environmental statement

FORKED RIVER NUCLEAR STATION UNIT 1

**JERSEY CENTRAL POWER AND LIGHT COMPANY
DOCKET No. 50-363**

February 1973

FIGURE III-4. FORKED RIVER STATION WATER SUPPLY AND DISCHARGE SYSTEMS

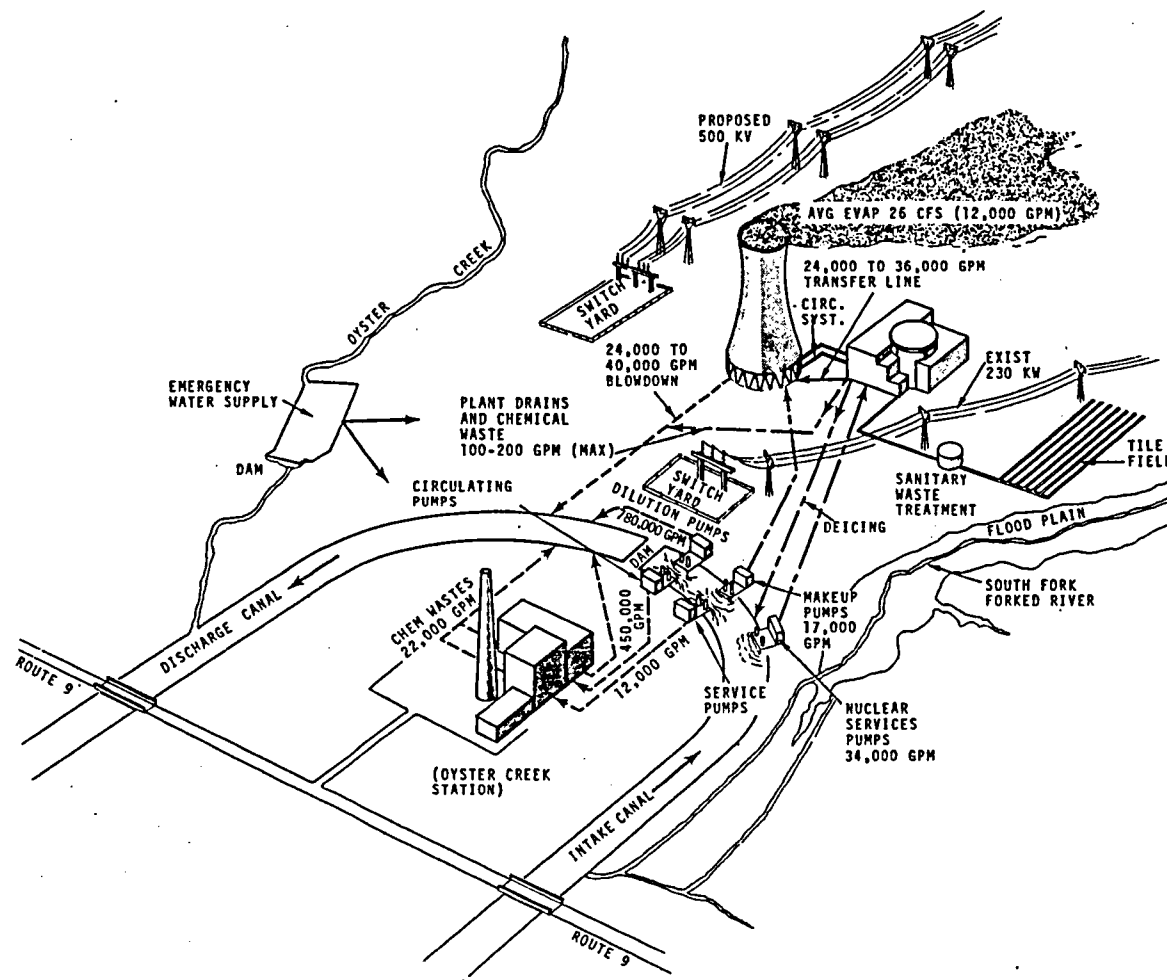
Figure III-4 shows the proposed integration of the Forked River Station operational system with that of the Oyster Creek Station. The sketch excellently depicts the Forked River Station water supply and discharge systems but totally neglects the Oyster Creek Station systems. It would seem desirable to include some details of the existing unit in the figure.

FIGURE III-5 SCHEMATIC OF FORKED RIVER LIQUID RADIOACTIVE WASTE SYSTEM

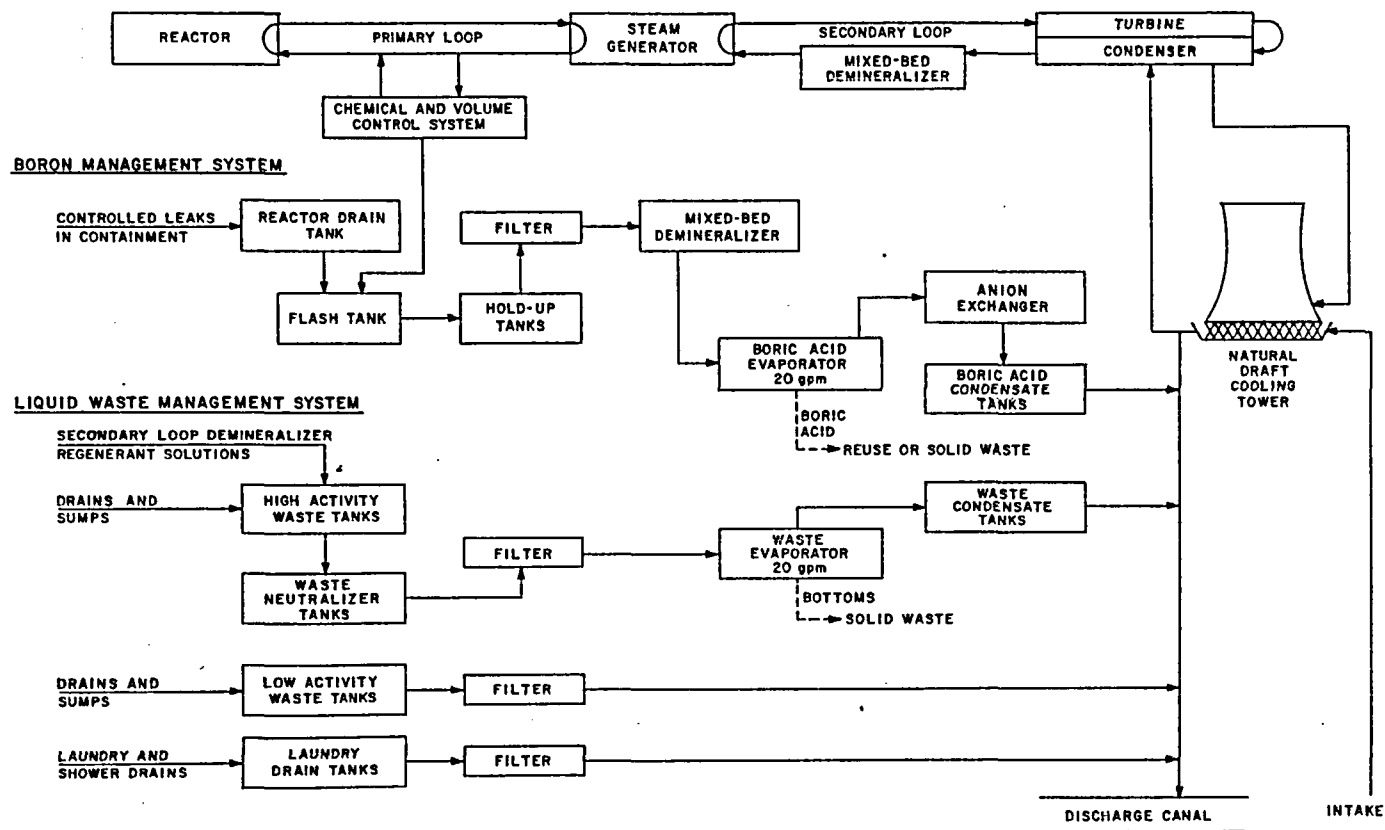
It appears that low activity (less than 10^{-5} uCi/cc) wastes and laundry wastes, which may contain significant amounts of radioactivity, will only be filtered before discharge. The final statement should include a detailed breakdown of all sources of liquid radioactive wastes, their expected volumes, and their radionuclide compositions; so that an evaluation of the significance of these various sources can be made. Also, Figure III-5 of the draft statement should be revised to include the pathways for steam generator blowdown and secondary system leakage. We encourage the applicant to utilize the waste treatment equipment in a manner to minimize radionuclide discharges to Oyster Creek (in particular long-lived radionuclides known to accumulate in the environment) and to follow the monitoring guidance of Safety Guide 21 for each potential source of radioactive liquid release.

Calculations were performed to determine the annual release from the laundry and other wastes that normally have an activity lower than 10^{-5} $\mu\text{Ci/cc}$. The release from this source was estimated to be 0.05 curie per year exclusive of tritium, and therefore considered to be negligible. Figure III-5 of the Draft Environmental Statement shows the regular flowpaths of the liquid radwaste system. Steam generator blowdown is done infrequently since the secondary water is purified by condensate demineralizers. The turbine building drains are not presently connected to the radwaste system. Therefore, neither of these pathways are shown in Figure III-5.
